HOTLINE FIX

Group: 54 – Chassis Electrical	**Original Date: 2nd February 2017**	**No. QE54-001**
Model: QE Pajero Sport	**Subject: Confirmation method and judgement of DRL brightness.**	
Revised on 11/02/2019..... (date) **Revised on** ..... (date) **Revised on** ..... (date)	Gary Van Gils National Service Manager Service Operations	
MMAL Ref TSL1612115	**Document consists of 4 pages.**

1. **Subject:** Confirmation method and judgement of DRL brightness.

Standard of part production lot

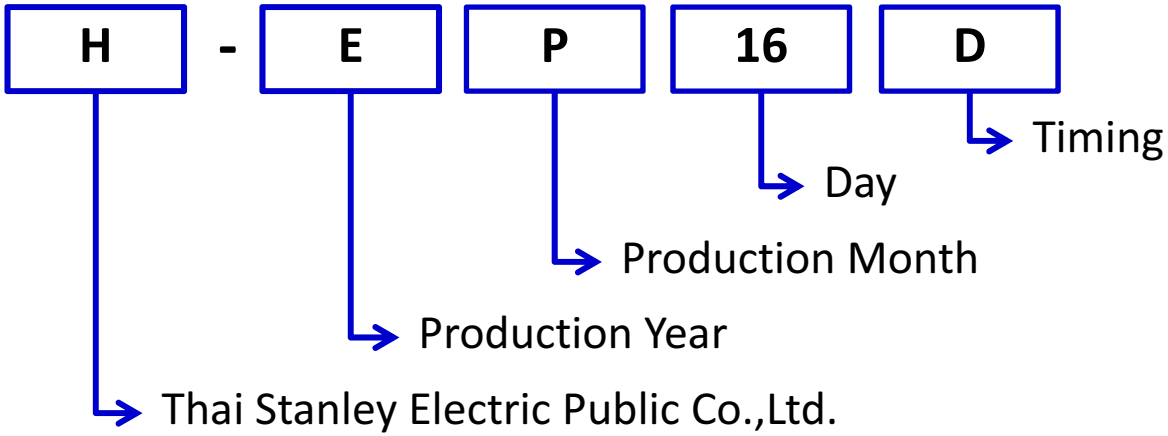
< Remark : Red circle ( ) in picture are yellow shade and unbalance brightness >

>*Please note : Effective at Headlamp unit on 15 Dec 2015 (Marking part : H-EP16D)
